Project	IEEE 802.16 Broadband Wireless Access Working Group < http://ieee802.org/16 >	
Title	Piggyback Bandwidth Request Handling in Distributed Scheduling	
Date Submitted	2007-05-09	
Source(s)	Masato Okuda and Yuefeng Zhou Fujitsu	okuda@jp.fujitsu.com Yuefeng.Zhou@uk.fujitsu.com

Re:	IEEE802.16j-07/013: "Call for Technical Comments Regarding IEEE Project 802.16j"	
Abstract	This contribution proposes a distributed bandwidth request and allocation mechanism.	
Purpose	To propose text to describe a distributed bandwidth request and allocation mechanism	
Notice	This document has been prepared to assist IEEE 802.16. It is offered as a basis for discussion and is not binding on the contributing individual(s) or organization(s). The material in this document is subject to change in form and content after further study. The contributor(s) reserve(s) the right to add, amend or withdraw material contained herein.	
Release	The contributor grants a free, irrevocable license to the IEEE to incorporate material contained in this contribution, and any modifications thereof, in the creation of an IEEE Standards publication; to copyright in the IEEE's name any IEEE Standards publication even though

Figure 1 Forwarding PB-BR from MR-BS to RS

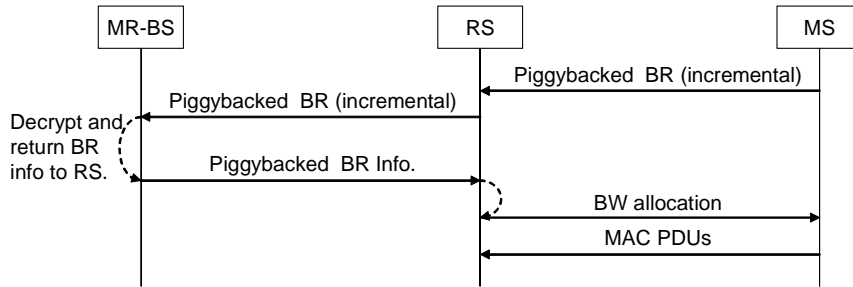
In centralized security systems, all all kinds of bandwidth requests except for encrypted piggybacked bandwidth request shall be locally handled by the access RS.

As for encrypted bandwidth request, the MR-BS decrypts MAC-PDUs and forwards piggybacked bandwidth request information to the access RS since RS cannot decrypt MAC-PDUs. See Figure 1.

Figure 2 Aggregate BR Header Superseding incremental PB-BR

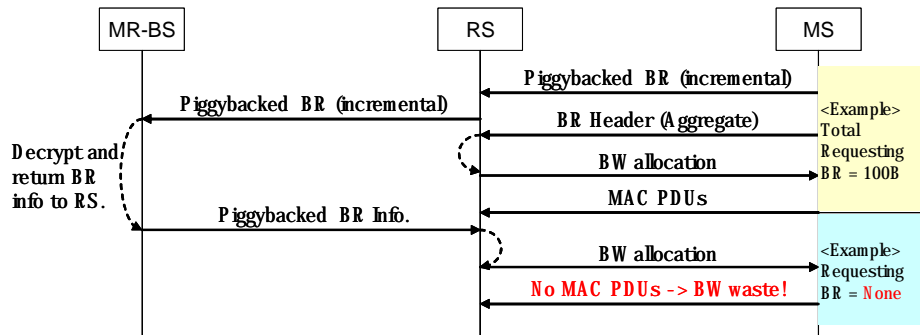
According to the current standard, MS must send BR header (Aggregate) periodically. Therefore, based on the Aggregate BR header, the RS may allocated all bandwidth requested by the MS before receiving PB-BR information from the MR-BS. In this case, bandwidth allocation based on the returned PB-BR information could be wasted. See Figure 2.

To prevent the above problem, Piggybacked BR Info sent by MR-BS shall contain packet number of MAC-PDU to which the Piggybacked BR request is attached. A MAC-PDU encrypted with AES-CCM shall contain unencrypted packet number. The access RS can use this value to manage ordering of bandwidth requests received from MS directly and via MR-BS.
